Cocos (Keeling) and Christmas Island, Sign & Pavement Marking Corrective Report

June 2019

Corrective Actions for Cocos (Keeling) West Island

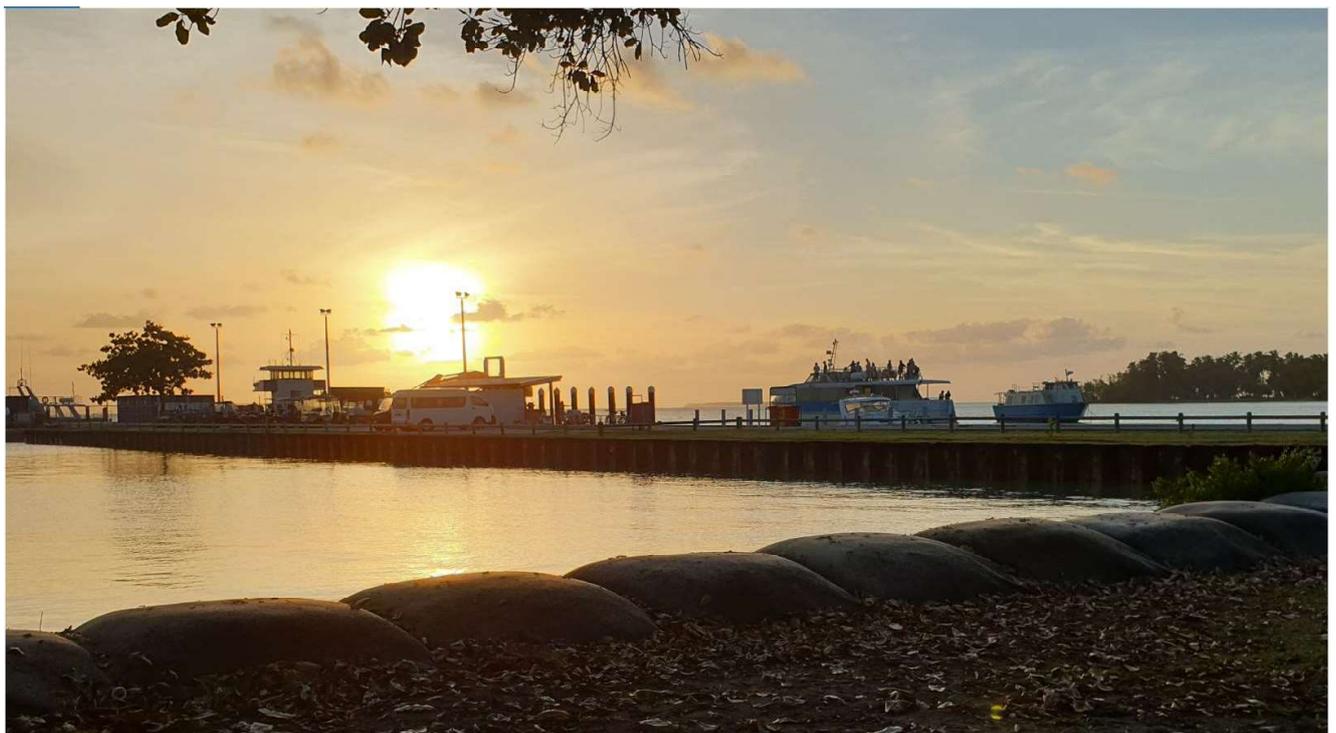
29. Immediately after this median treatment, there are a number of warning signs.

Given the sparsely populated island and little tourist traffic, these signs are unnecessary and don't provide any real safety improvement. Recommendation is to remove them completely.
